Product Change Notification

Document No. PCN-A-1061020 **Revision** 1.0

PCN TOPIC: Winmate has changed the mechanical part of M101H Tablet PC.

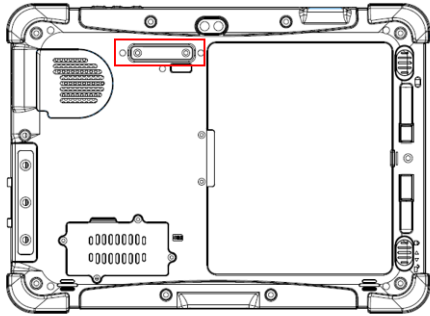
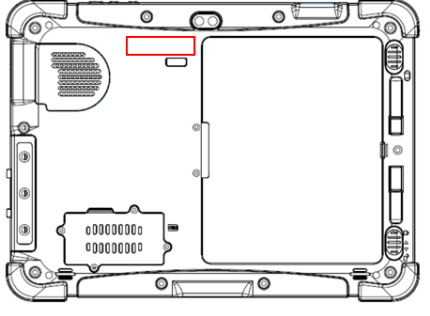
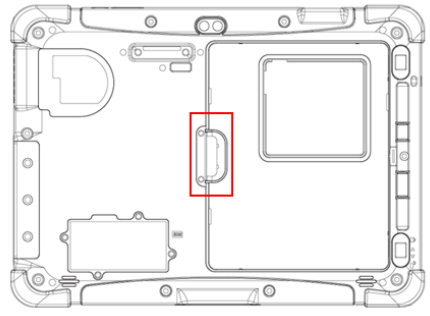
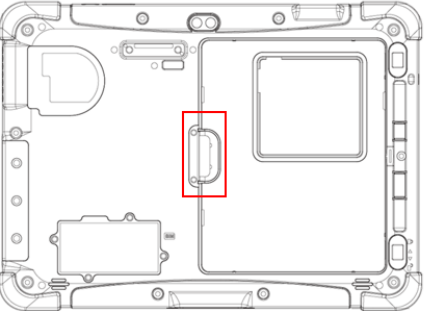
1. Strengthen rubber bumper design.
2. Remove optional expansion port.
3. Enhance battery waterproof solution from battery sink (tablet side) to replace waterproof rubber on battery pack.

| Mechanical | Old | New |
|---------------------------------|---------|---------|
| Bumper thickness difference | 23.5 mm | 28.5 mm |

| <p>Remove optional expansion port</p> | <p>Optional expansion port</p>  | <p>Without expansion port</p>  |
| <p>Enhance battery waterproof solution from battery sink (tablet side) to replace waterproof rubber on battery pack</p> | <p>With rubber on battery side.</p>  | <p>Without rubber on battery side.</p>  |

Based on the rubber bumper design change, customer can't use the old vehicle docking and office docking with this new design M101H. Please use the new part number listed as below.
